SHEET NUMBER 4	DRAWN BY: AS SHOWN	SCALE: AS SHOWN	WINDLER - HARVEST ROAD INFRASTRUCTURE SITE PLAN HARVEST ROAD - 48TH AVE TO 56TH AVE ROADWAY PLANS	WINDLER PUBLIC IMPROVEMENT AUTHORITY 5750 DTC PARKWAY, SUITE 210 GREENWOOD VILLAGE, CO 80111 PHONE: (303) 795-9900	 10333 E DRY CREEK RD SUITE 240 ENGLEWOOD, CO 80112 TEL: 720.482.9526 Westwoodps.com Westwood Professional Services, Inc.
	CHECKED BY: DJD	DATE: August 2023	Revisions	No.

WINDLER - HARVEST ROAD INFRASTRUCTURE SITE PLAN
HARVEST ROAD - 48TH AVE TO 66TH AVE
ROADWAY PLANS

**HARVEST RD INFRASTRUCTURE SITE PLAN
48TH AVE TO 56TH AVE
LANDSCAPE PLAN**

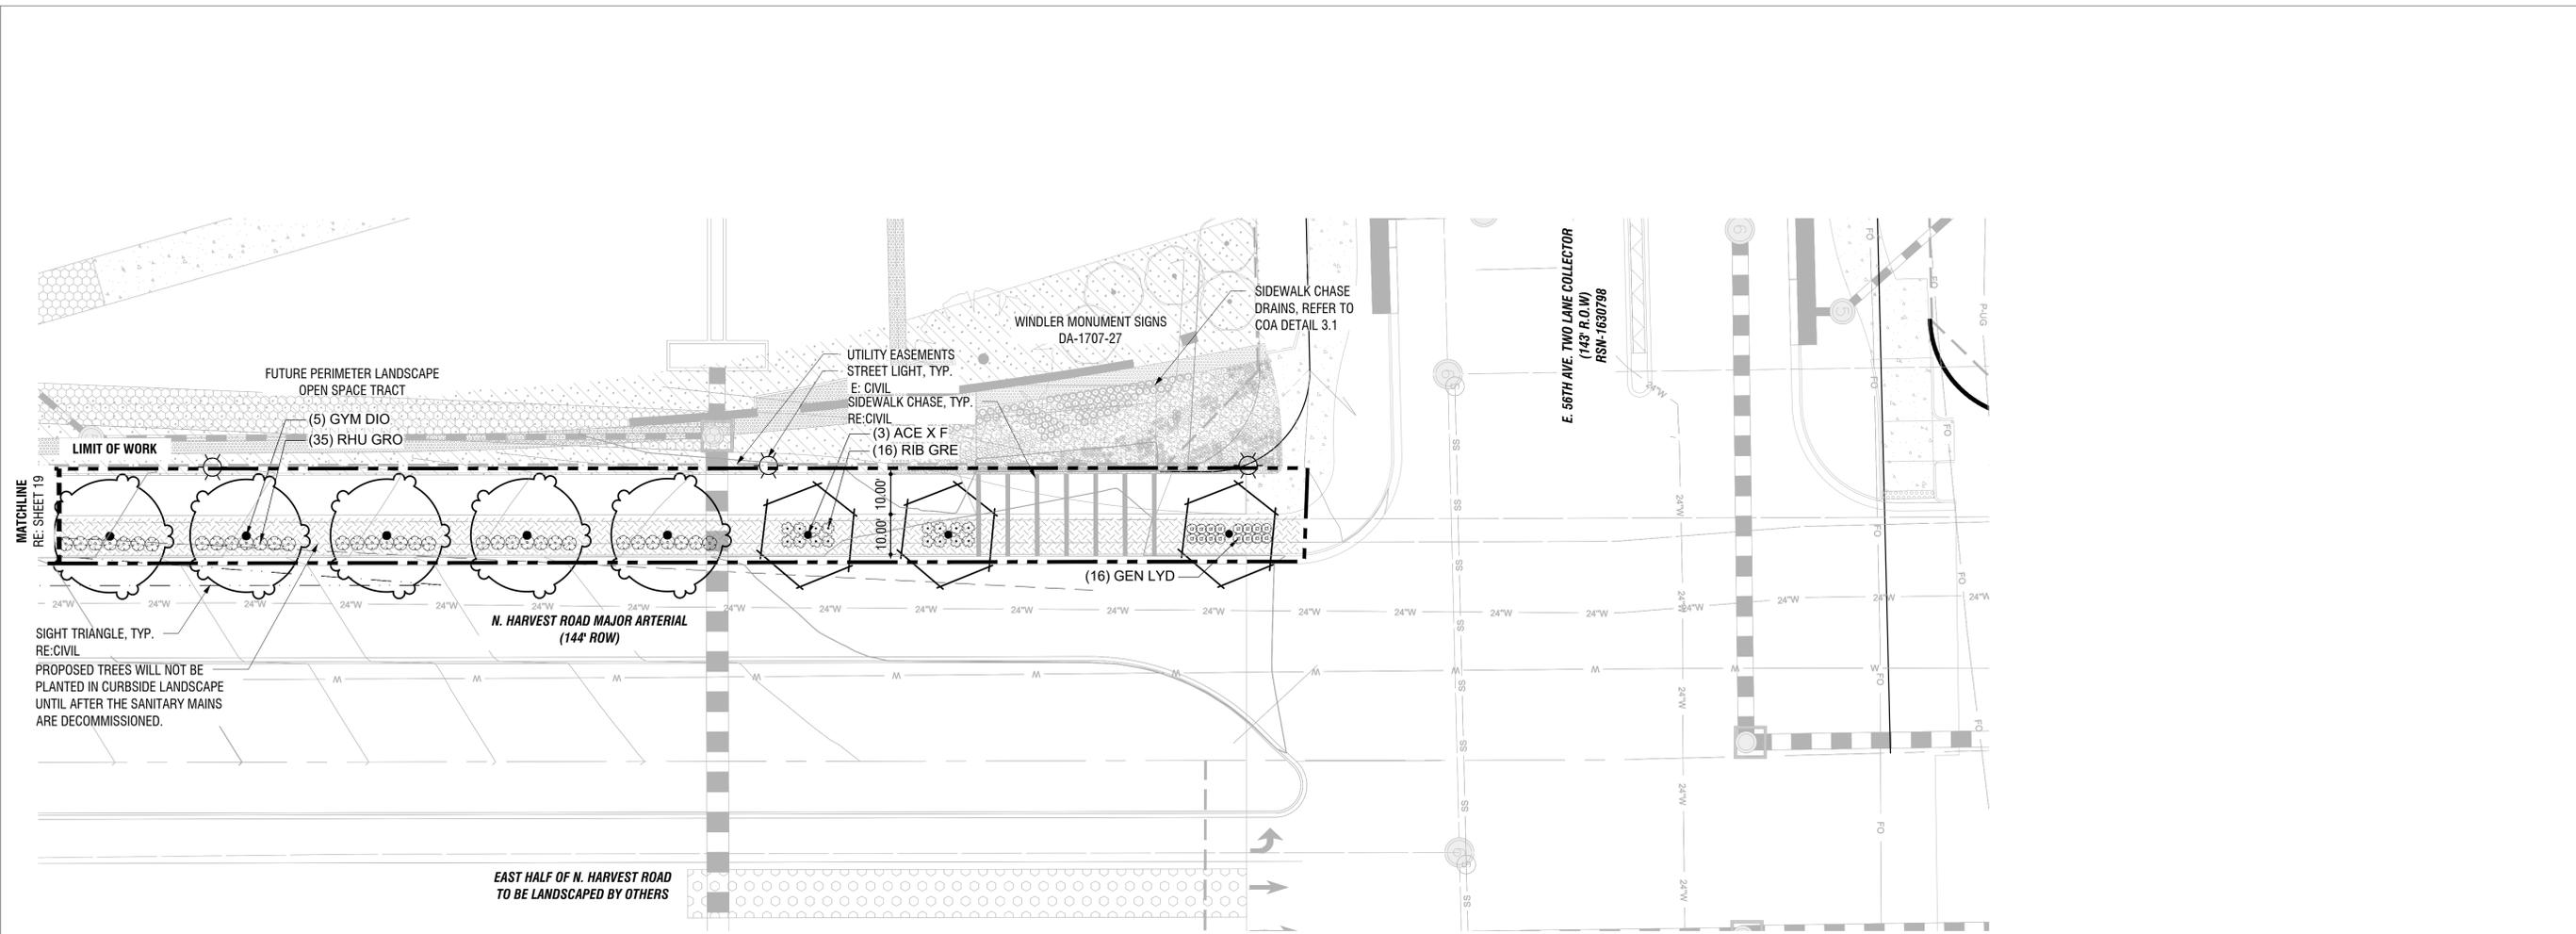
Add the required City of Aurora Landscape Notes. They were included with the previous submission.

Remove from this sheet.
removed.

added

tree count updated
